RE: **Lot 16 Block 6 Unit 18, S.A.D. 228**
6512 Kimmick Dr NW
Grading and Drainage Plan
Engineers Stamp Date 9-7-17 (D10D003b11)
Pad Certification Dated 9/24/17

Based upon the information provided in your submittal received 9/27/17, this plan is approved for Grading Permit and Building Permit.

MICHAEL SANCHEZ – CRUZ & BRENDA – GRADING & DRAINAGE PLAN

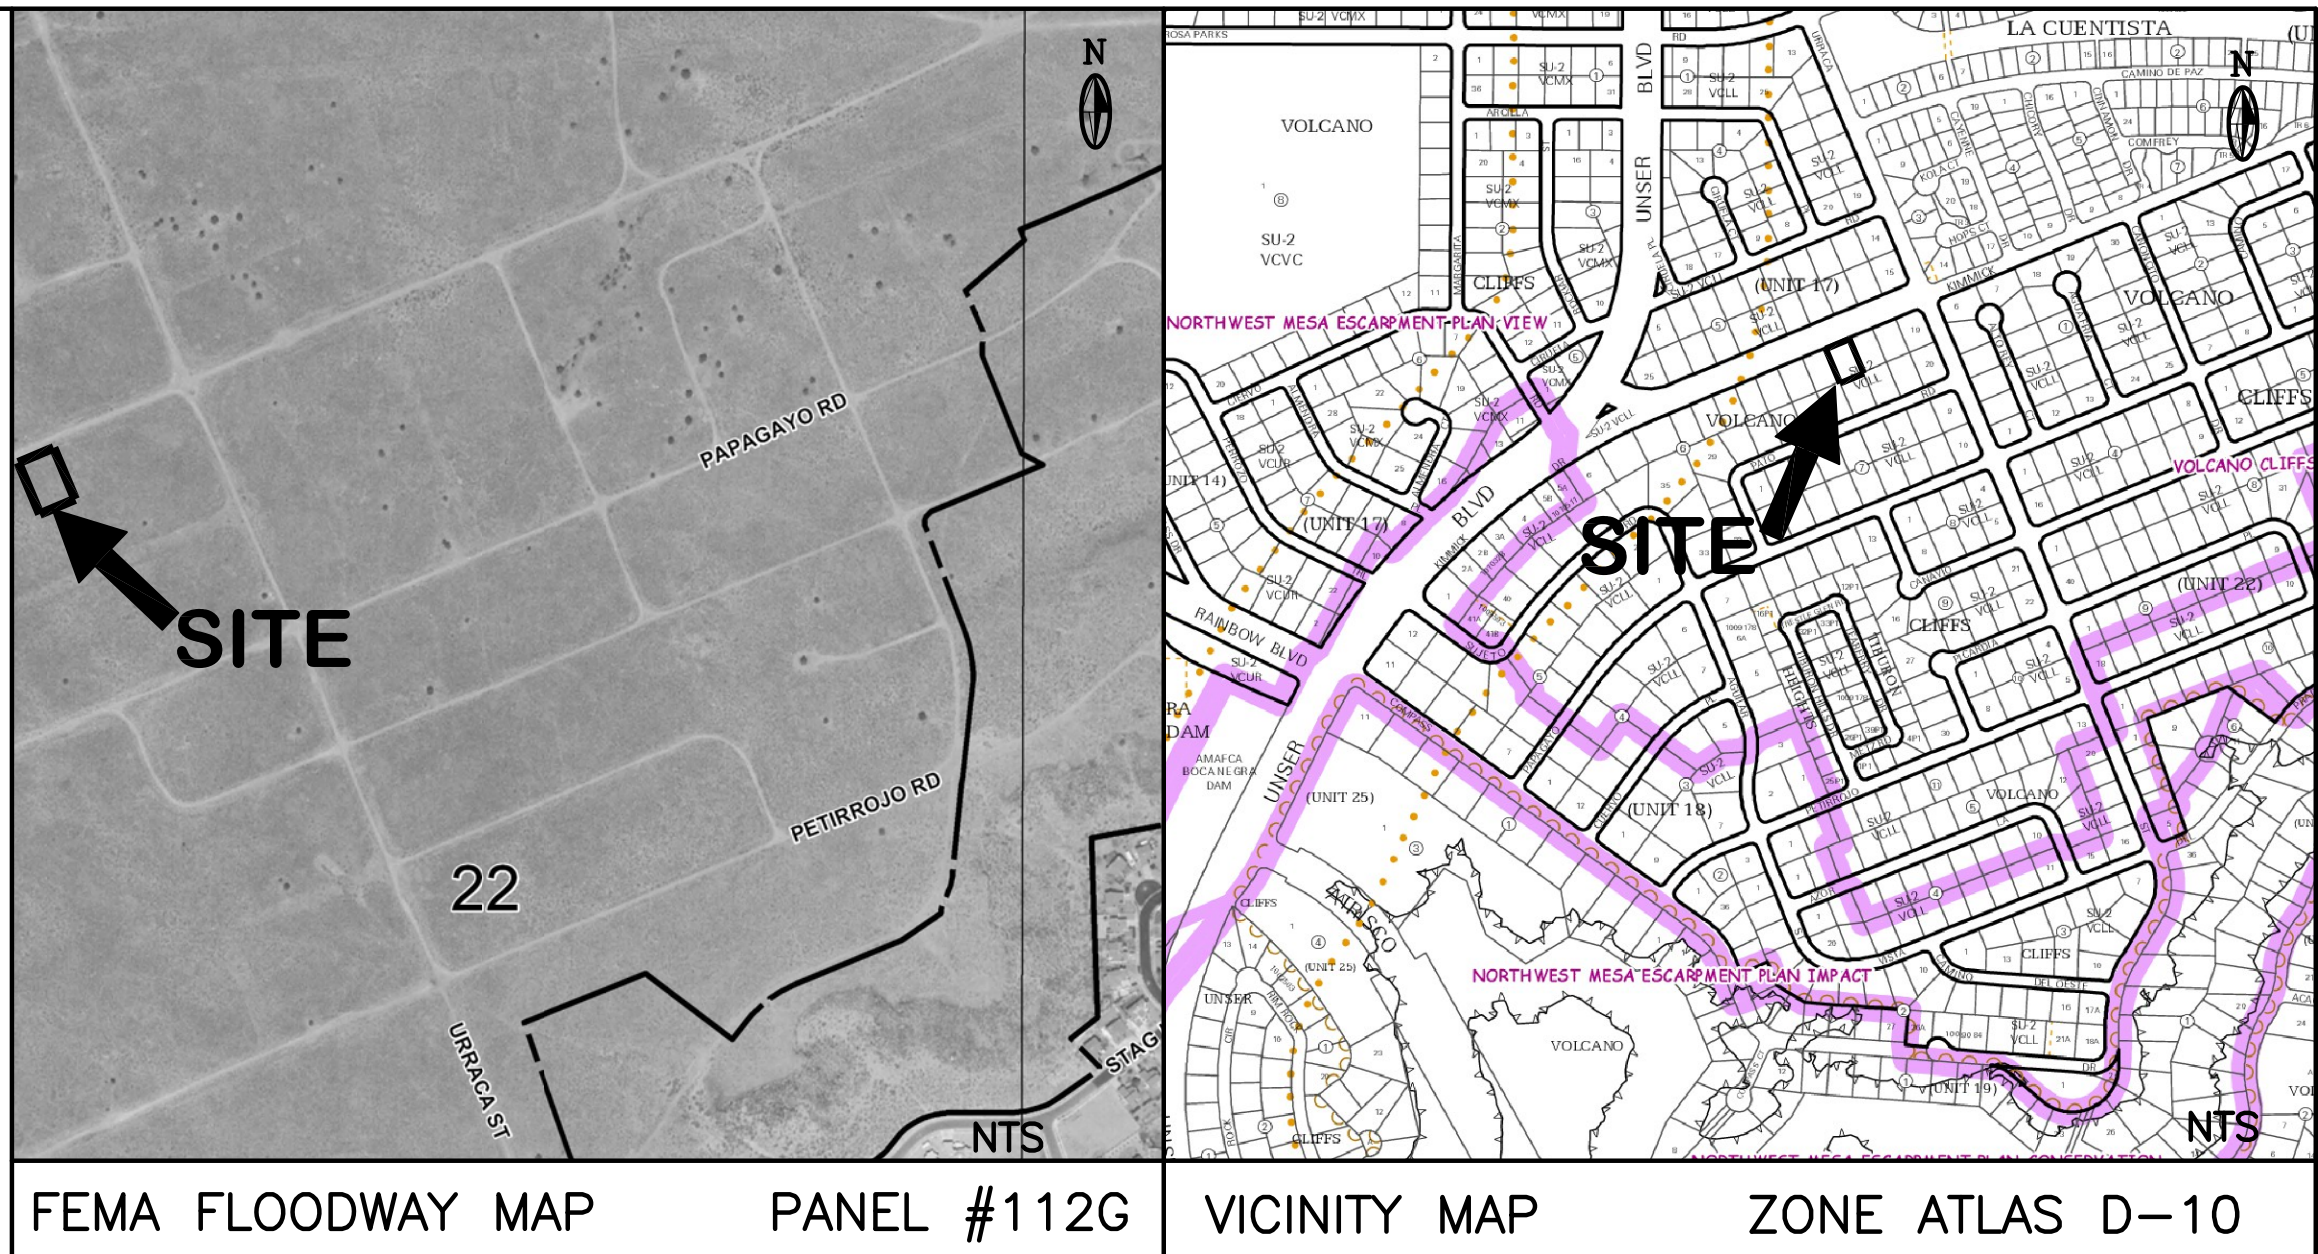
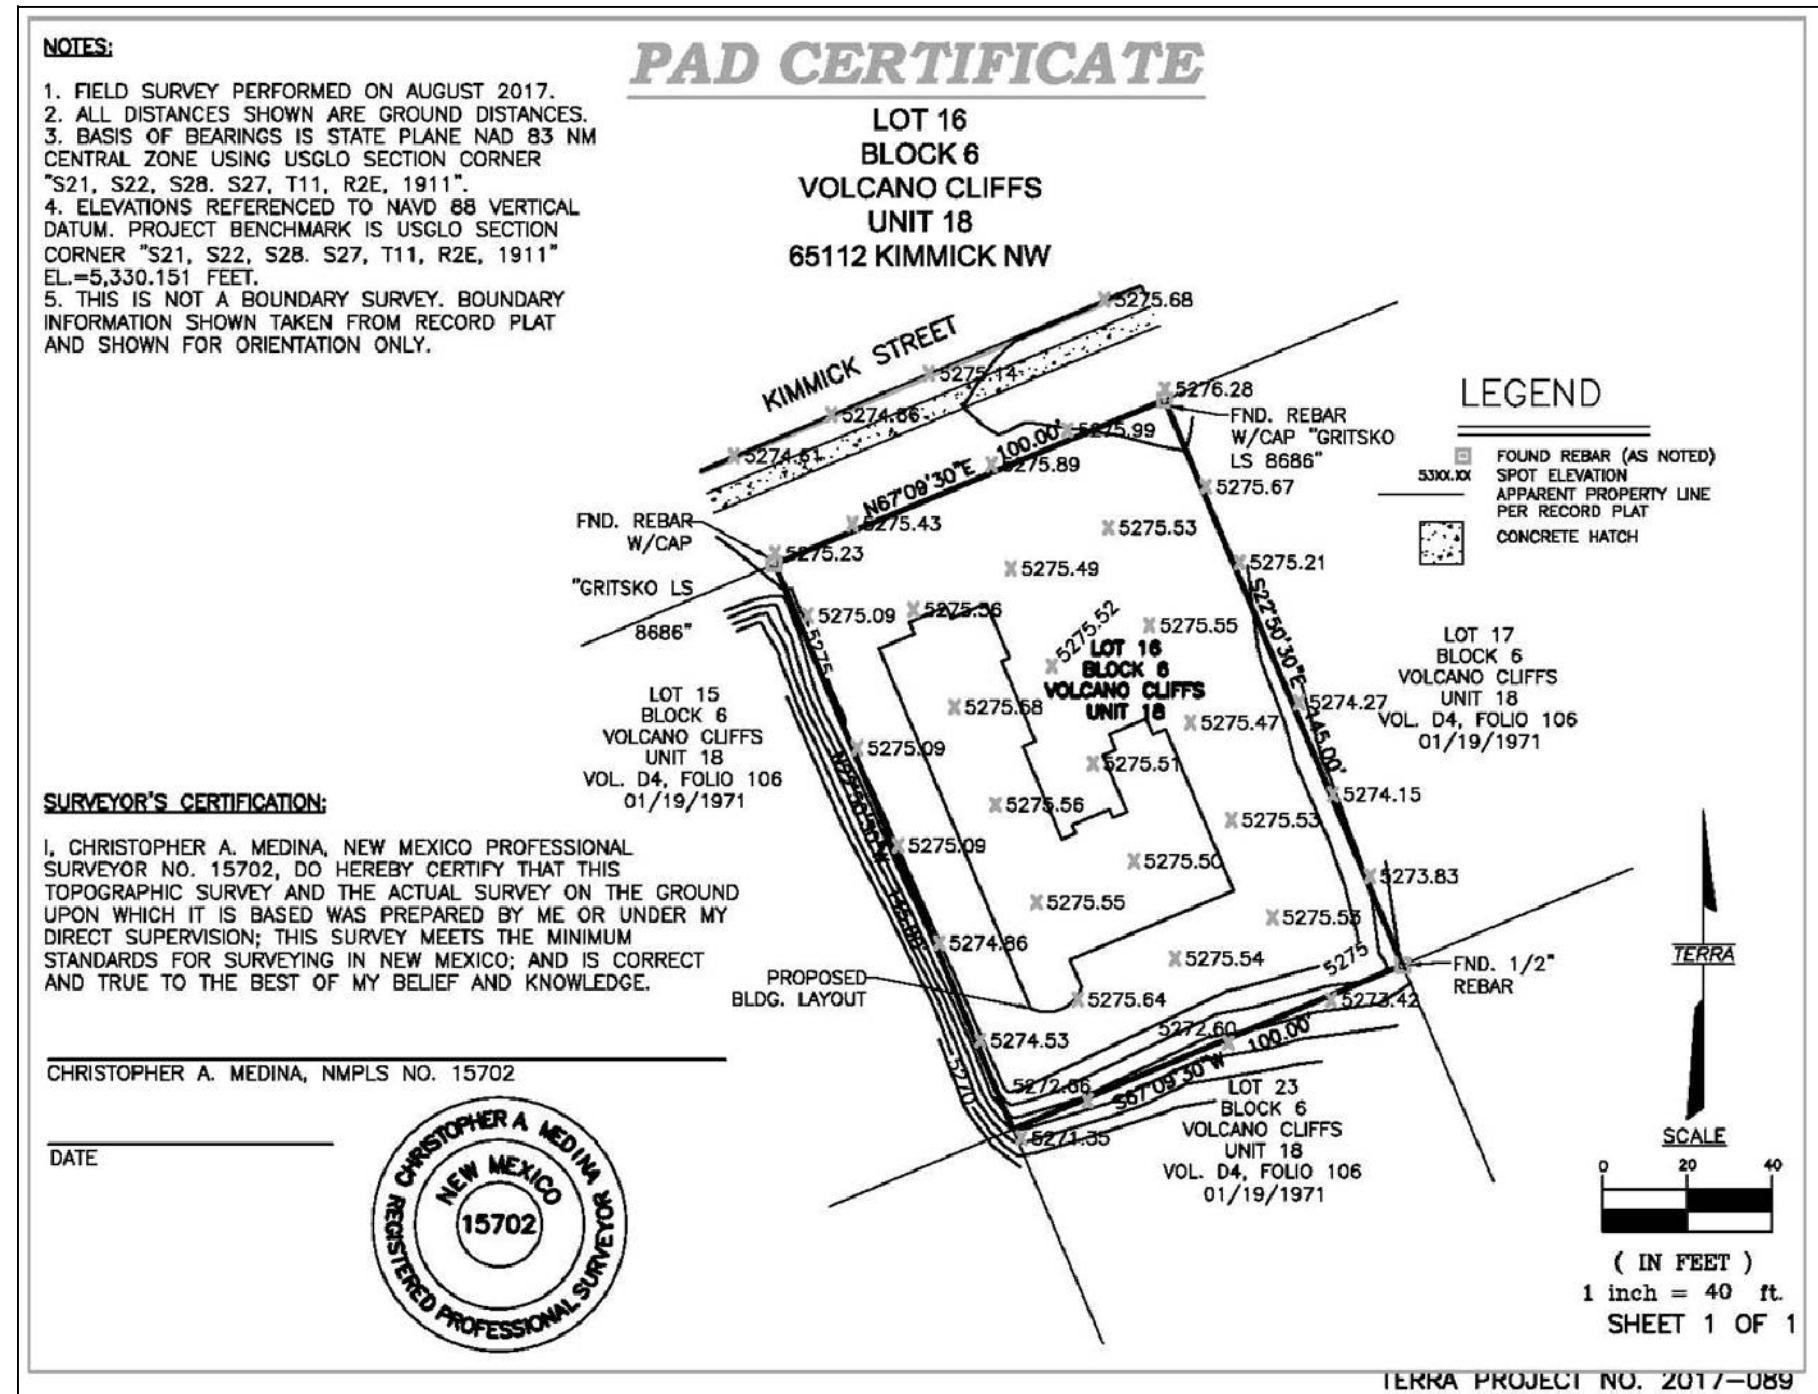
Please have the owner/builder attach a copy of this approved plan, to the construction sets in the permitting process prior to sign-off by Hydrology. Reiterate to the Owner/Contractor that a separate permit for a garden/retaining wall must be obtained, with the approved G&D plan dated 9/24/17.

Prior to Certificate of Occupancy release, Engineer Certification per the DPM checklist of this plan will be required.
